AMENDMENT OF SOLICITATION/MODIFICATION OF CONTRACT			1. CONTRACT ID CODE J	PAGE OF PAGES 1 2
2. AMENDMENT/MODIFICATION NO. 0002	3. EFFECTIVE DATE 03-Jul-2007	4. REQUISITION/PURCHASE REQ. NO.		5. PROJECT NO.(If applicable)

14. DESCRIPTION OF AMENDMENT/MODIFICATION (Organized by UCF section headings, including solicitation/contract subject matter where feasible.)				
1. This amendment is issued to replace the following drawings in their entirety: Sheet S-1 (AF0715 B-SB01PN) and Sheet S-2 (AF0715 B-SB02EL)

COUNTER EXPLOSIVES SCHOOL
ANA COMANDO COMPLEX
RISH KHOVOOR, AFGHANISTAN
MUNITIONS STORAGE IGLOO TYPE A
FOUNDATION PLAN AND SECTION

COUNTER EXPLOSIVES SCHOOL
ANA COMMANDO COMPLEX
RISH KHOVDOR, AFGHANISTAN
MUNITIONS STORAGE IGLOO TYPE A
PORTAL WALL
PLAN, ELEVATION AND DETAILS

SHEET REFERENCE NUMBER:
B
S-1

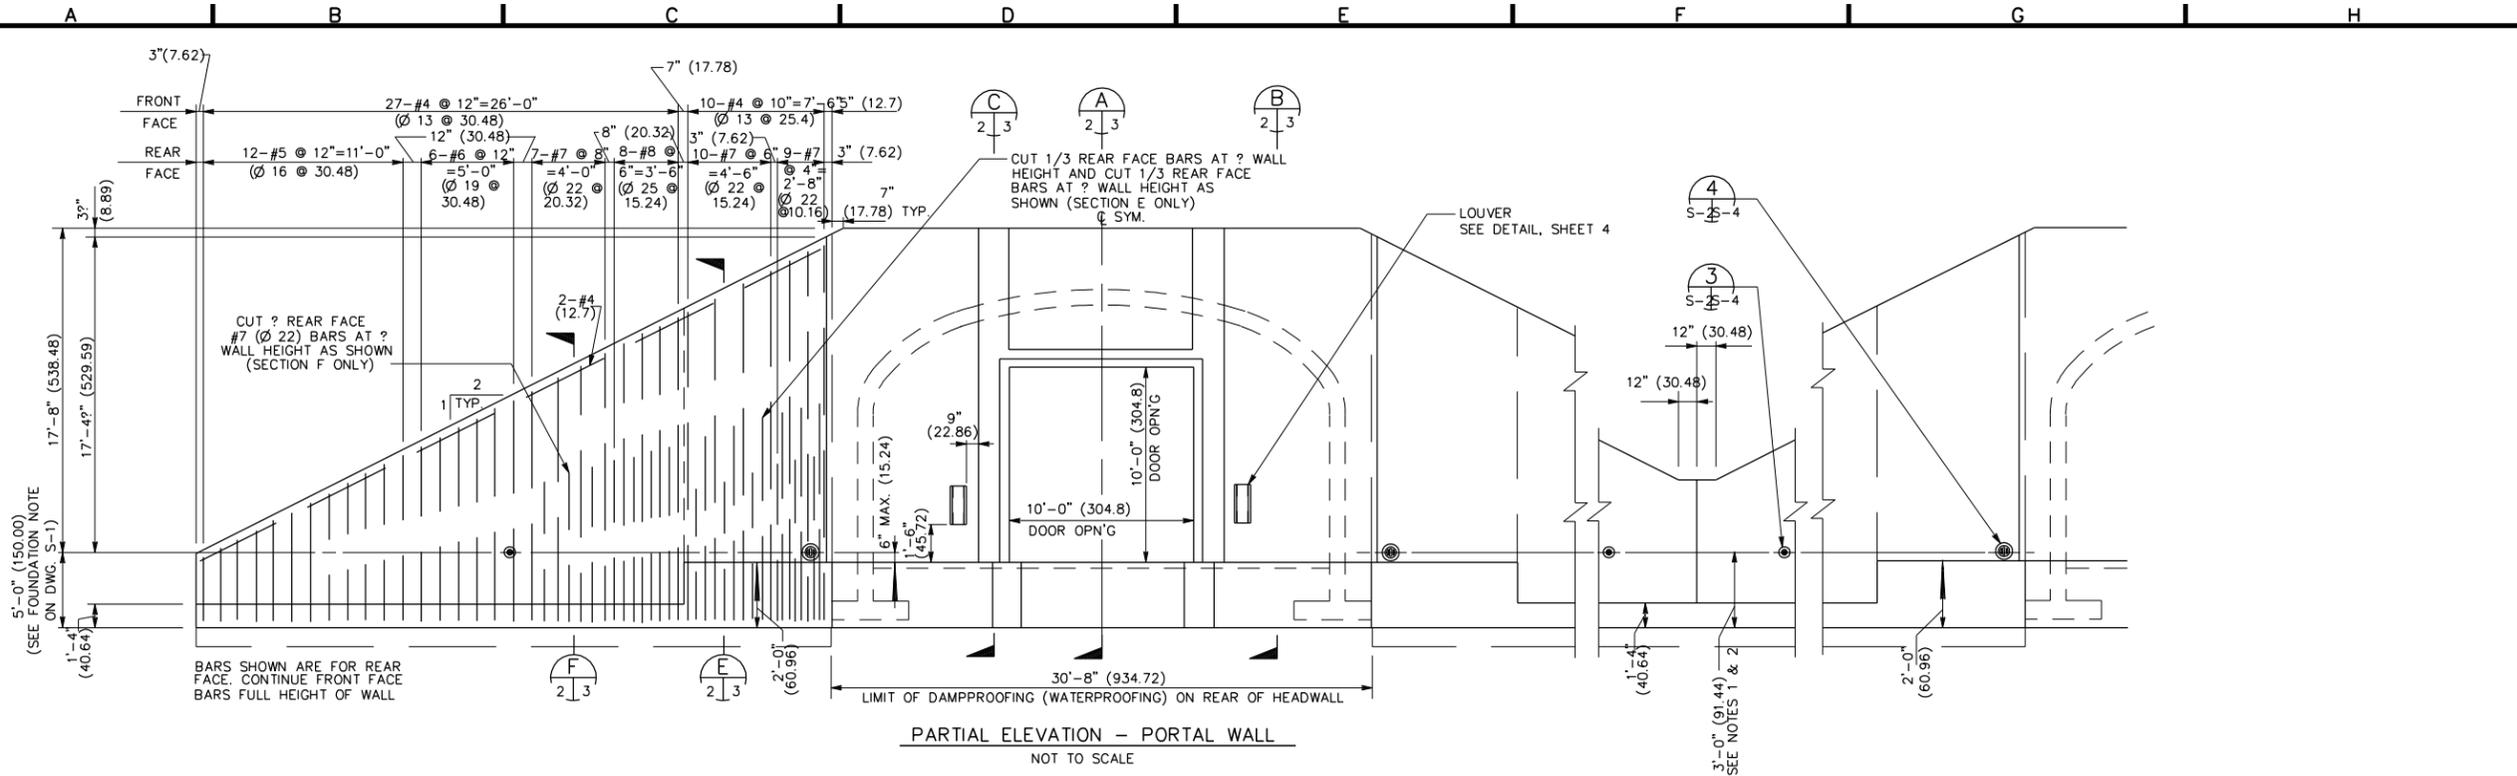
SYMBOL	AM#2	ADDED	IGLOO	DESCRIPTION	DATE	APP.
					06-29-07

SHEET REFERENCE NUMBER:
B
S-2

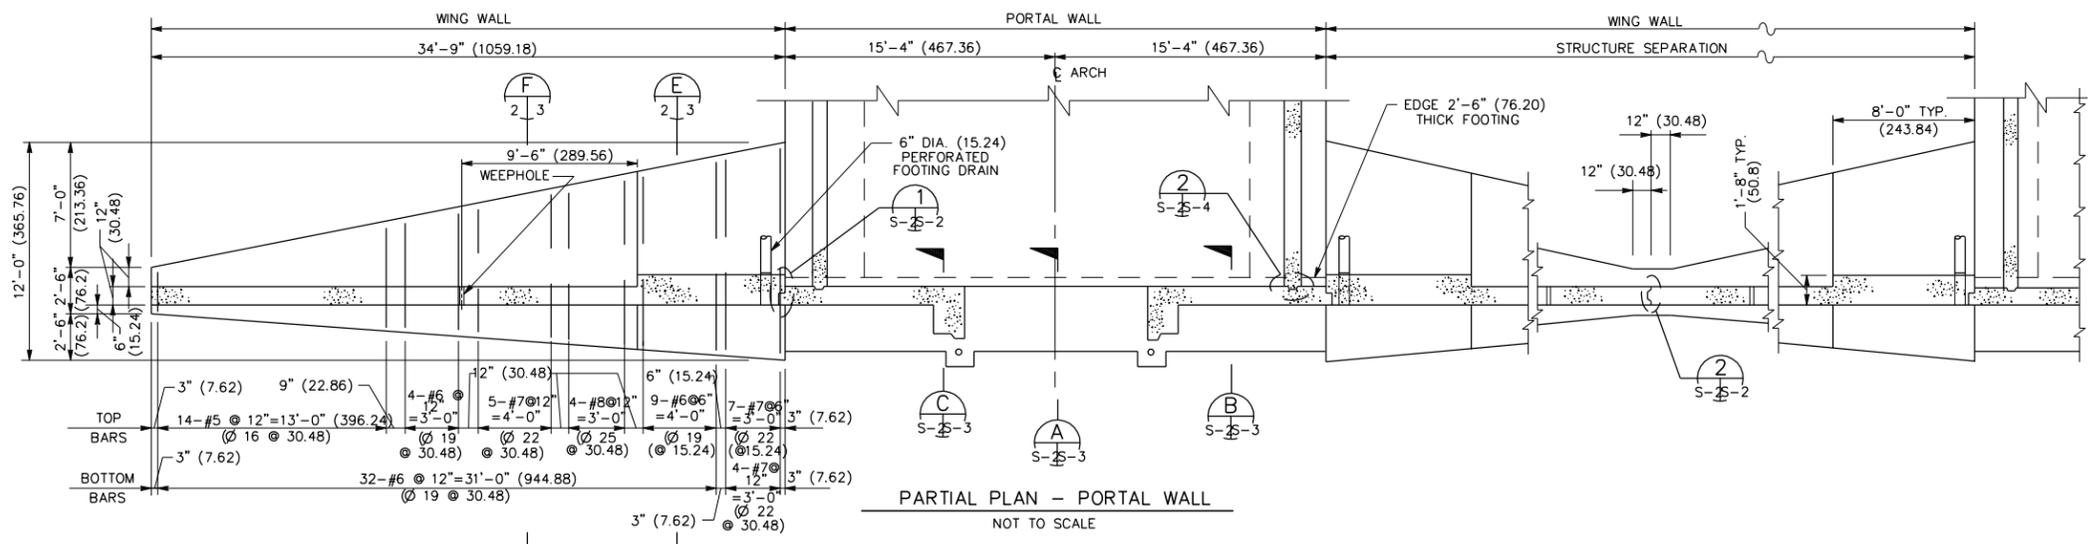
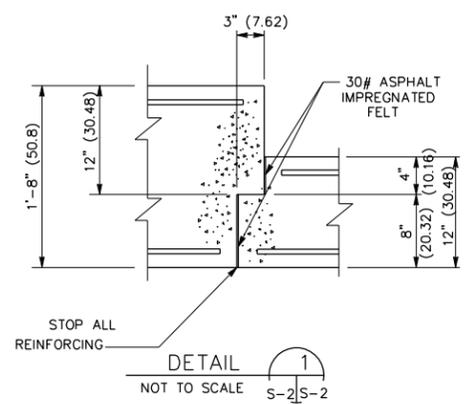
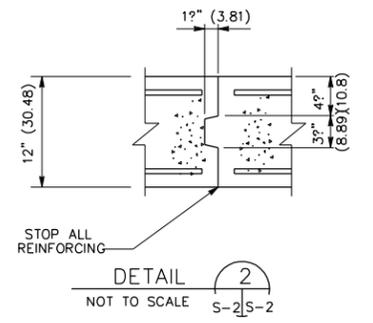
SYMBOL	AM# 2	ADDED	IGLOO	DESCRIPTION
DATE	06-29-07
